Ride The Ducks International
RTDI - TECHNICAL SERVICE BULLETIN

TSB TITLE: Instrument Panel Indicators & Illumination	DATE: 8-10-17
--	----------------------

RTDI BULLETIN NO. TSB-02-17 NHTSA RECALL NO: 17V-165	MODEL: All Truck Ducks & Stretch Ducks
---	---

Fig #1 ← Horizontal to Dash →

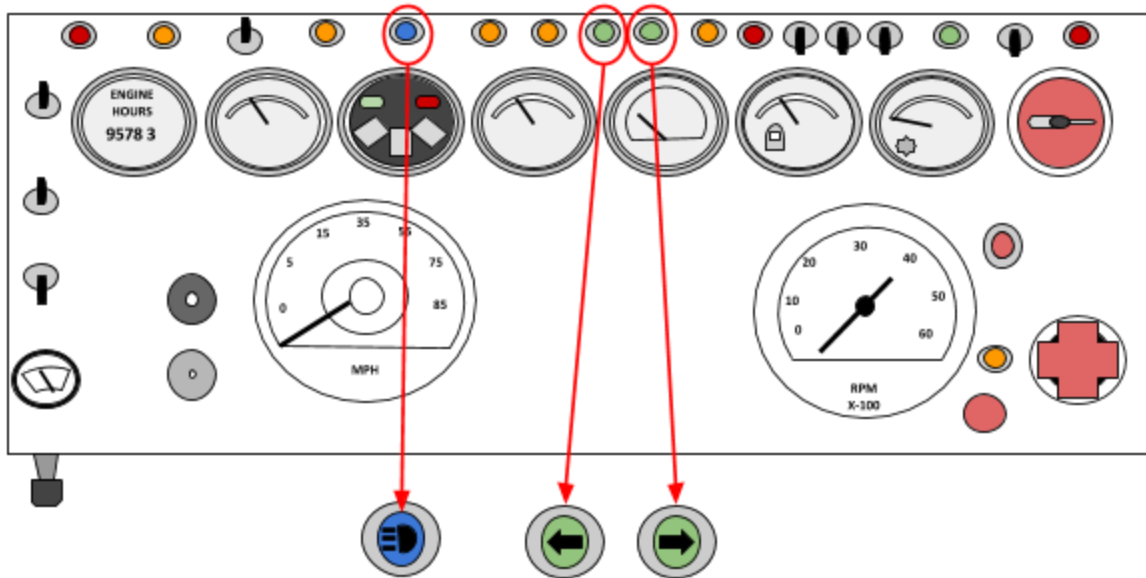
REASON: To make the dash turn signals and high beam indicator compliant with FMVSS 101 by illuminating the windshield wiper switch for nighttime operations and display the associated turn signal symbol.

1. See page 1. Fig #1 to establish which dash lights require decals.
2. Clean each light thoroughly with rubbing alcohol or soap and water. Do not use Windex or similar products because it will leave a residue behind that will prevent the sticker from adhering well.

3. Prepare the sticker for application by aligning outside black circle on the decal with the outside chrome ring on the light. See Fig#2 on page. 1
4. Ensure arrows are centered onto the lens and arrows are horizontal to the dash.
(See page. 1 Fig. (1-2))

5. Peel backing off sticker and apply to light as described in #3-4 above.
 - Note: firmly rub finger across the surface to remove any air bubbles.
6. Slowly peel clear transfer tape off at an angle. Be careful not to pull the sticker off the surface.

Fig #1

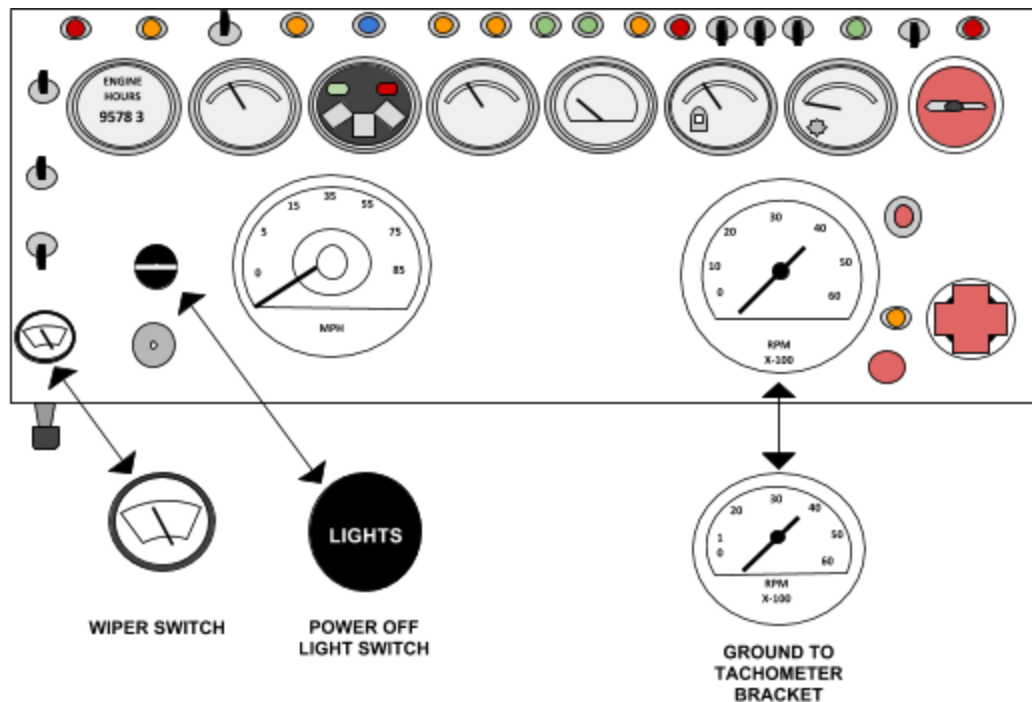
1. The Windshield wiper light is to be wired (powered) off the headlight switch. When the headlight switch is turned on, the windshield wiper switch light, illuminates the wiper switch. See page. 2-3 Fig (1-2)
2. There is a red and black wire connected to the windshield wiper light. Connect the (Red) wire to the pole marked (T) on the light switch. Connect the black wire to the ground on the Tachometer gauge bracket. See page. 4 wire diagram Fig 3
 - **NOTE:** The ground can be connected to any dash gauge bracket.
3. Secure the light to the side of the cowling wall directly adjacent to the windshield wiper switch. Ensure when the light is illuminated the wiper switch is visible. Adjust light location as necessary to ensure proper illumination. See page. 5 Fig 4.
